Response:

Planning and Design codes

February 2020

From:
Heath Edwards MPIA FAILA
Chair of the South Australian Active Living Coalition
M: [REDACTED]

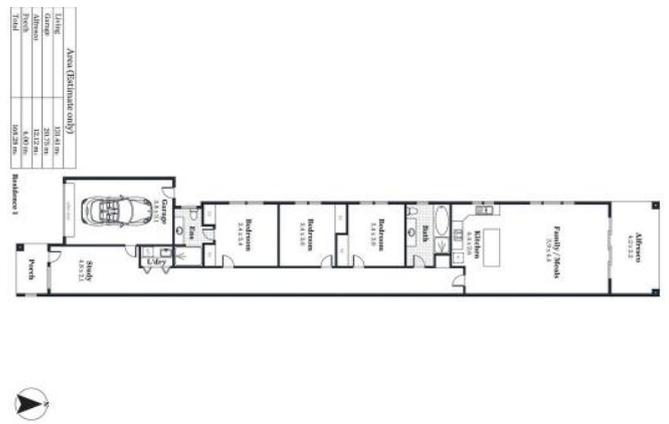
Does the Code enable usable private open space and mitigate heat? Most at ground private open space off a habitable room is used for seating and/or alfresco dining, similar to the use of balconies. This function of POS requires 2m of the 3m minimum width would be hard surface to support outdoor furniture. Coalition members have concern that the current system and proposed Code allows development that increases urban heat and provides very little natural outlook from living spaces. Development such as the ones below are found often in urban areas which have been re-zoned to allow single suburban homes to be demolished and replaced by multiple dwellings.

The question is Can 16m² of private open space with no requirement for soft surface adequately compensate for 2, potentially 3 storeys of dwelling with all the accompanying hard surfaces? Would a requirement for soft landscaping within private open spaces be able to mitigate the heating effect of constructing multiple 2 or 3 storey townhouses on a block that used to house a single dwelling if a requirement for soft landscaping was included?

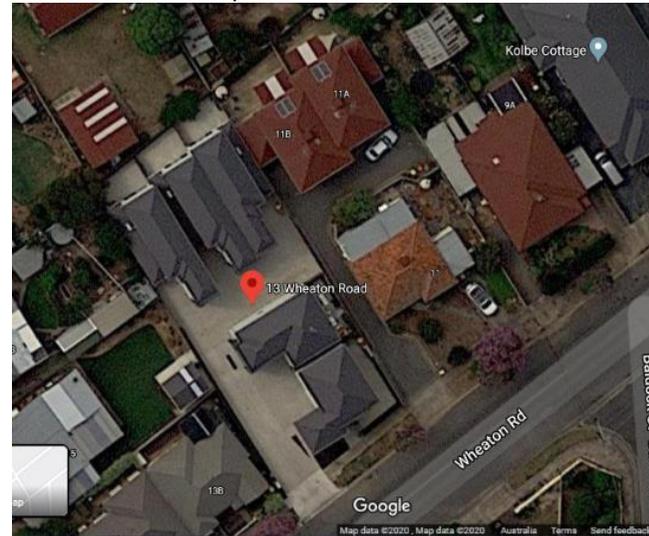
<p>Landscaping</p> <p>PO 34.1 Landscaping is provided between dwellings and common driveways to improve the outlook for occupants and improve the appearance of common areas.</p> <p>DTS/ DPF 34.1 Other than where located directly in front of a garage or directly adjacent a building entry door, soft landscaping with a minimum dimension of 1m is provided between a dwelling and common driveway.</p>	<p>The Coalition supports requirements for landscapng particularly for group battle-axe developments to reduce poor-quality development such as this recent build below</p>

Landscaping in this view represents all landscaping for 5-3bedroom + 2 bathroom townhouses. Narrow width of landscaping means poor growth and limited shade potential.
